From: Greg Boston
Sent: 16/09/2025 3:55:24 PM
To: Lachlan Rose; David Landsberry
Cc: Council Northernbeaches Mailbox
Subject: Objection - Development Application DA2025/1156 - 23 Beatrice Street, Clontarf
Attachments: Objection - DA2025 1156 - 23 Beatrice Street Clontarf - Final.pdf;

Notification Response
Development Application DA2025/1156
Alterations and additions to a dwelling house
23 Beatrice Street, Clontarf

Figure 3 - Plan extract DA 130/2015 showing no entry level roof terrace.

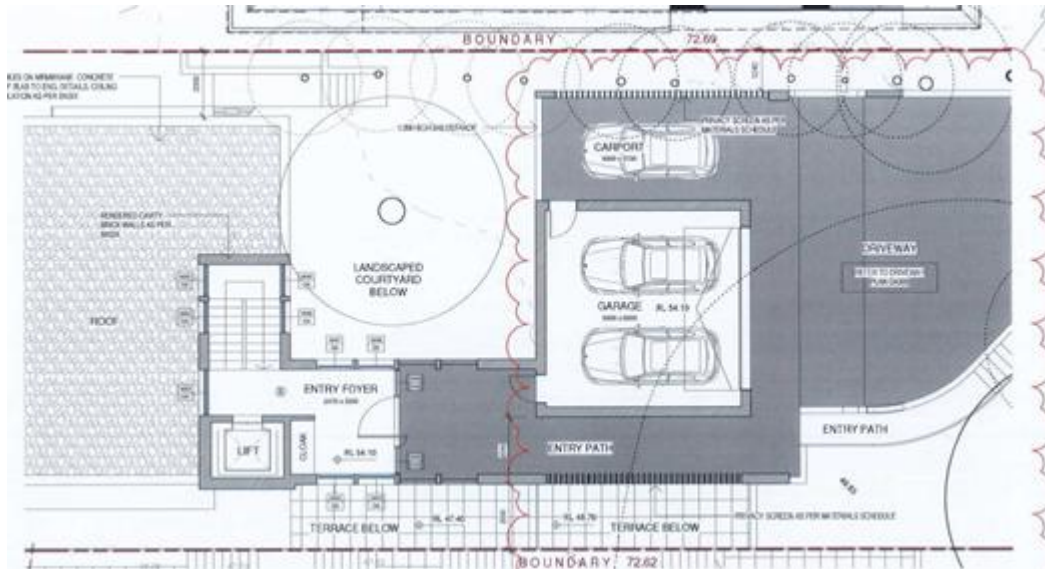
We have reviewed our original SoEE and note that there is no reference to the “as built” entry-level roof terrace nor is it nominated on the original development application plan extracts at Figures 2 and 3. Further, the clause 4.6 variation request prepared in support of the original development application does not reference any entrance level terrace noting that any balustrade associated with this terrace would also have been building height non-compliant.

On this basis, it would appear that the existing entry-level terrace is unauthorised and accordingly the application must fail at law given the inability to regularise unauthorised works by way of development consent.

Figure 5 – Plan extract DA12(A) - Visual Impact Assessment

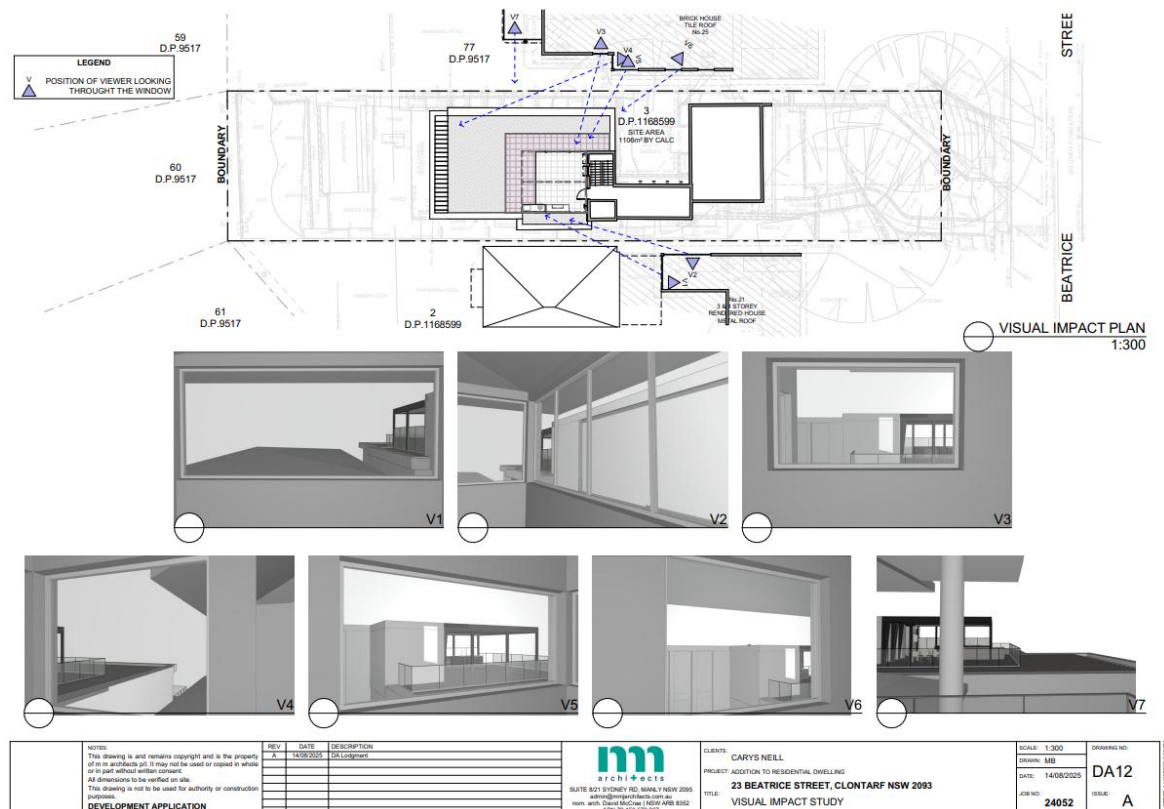
The same can be said for the property to the north of the subject site at No. 25 Beatrice Street as depicted on plan DA12A (Figure 5) which will experience significant visual and aural privacy and view loss impacts.

Further to the above, the required shadow diagrams are inadequate as they do not differentiate the shadowing caused by the building height non-compliant awning structure. However it is clear that the non-compliant structures will give rise to additional shadowing impact to the north facing windows and balconies on all levels and rear private open space area of our client's property on 21 June. Further, it is clearly evident from our site view that the awning structure will be visible from Beatrice Street and to that extent will impact views available from the public domain, our client's upper-level west facing window and 25 Beatrice Street as depicted in Figure 5.
